DIAGRAM #1

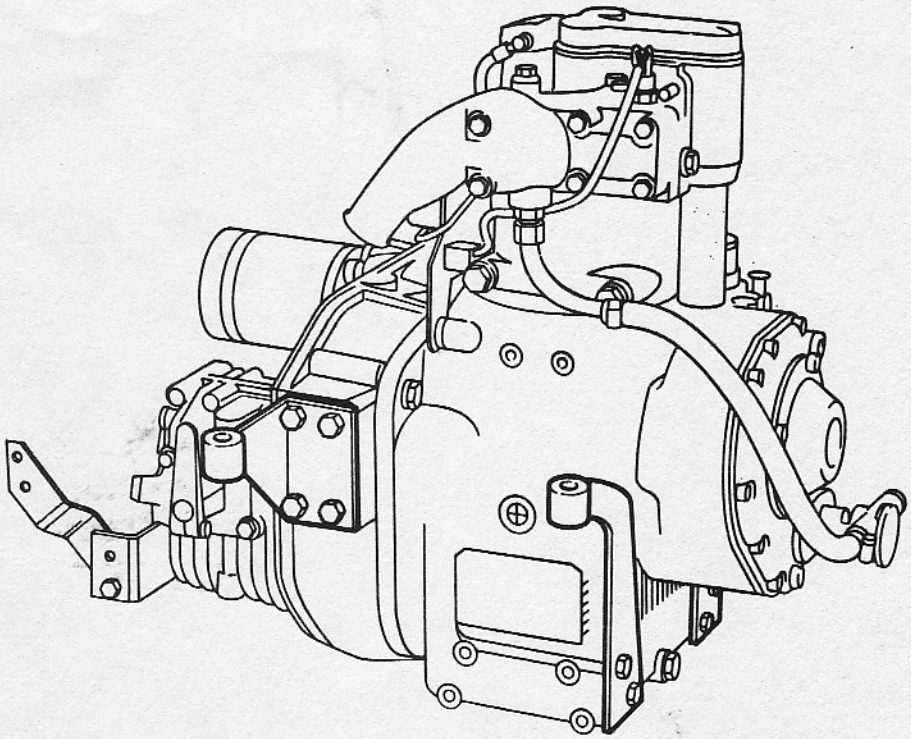
6. A four point conical mount system is available for retrofit of the previously standard 2 conical and two rubber bearing mount system. The four point mount system includes the following parts and quantities necessary to change D-12 from standard to modified mounting.

It will be necessary to reverse original front engine brackets. See diagram # 1.

Rubber mount	-	P.N. 11 81 1 333 259 - 4
Nut M 16 x 1.5	-	P.N. 07 11 9 922 176 - 8
Washer	-	P.N. 07 11 9 931 094 - 8
Front bracket	-	P.N. 11 81 1 333 627 - 2
Front bracket bolts	-	P.N. 07 11 9 913 834 - 4
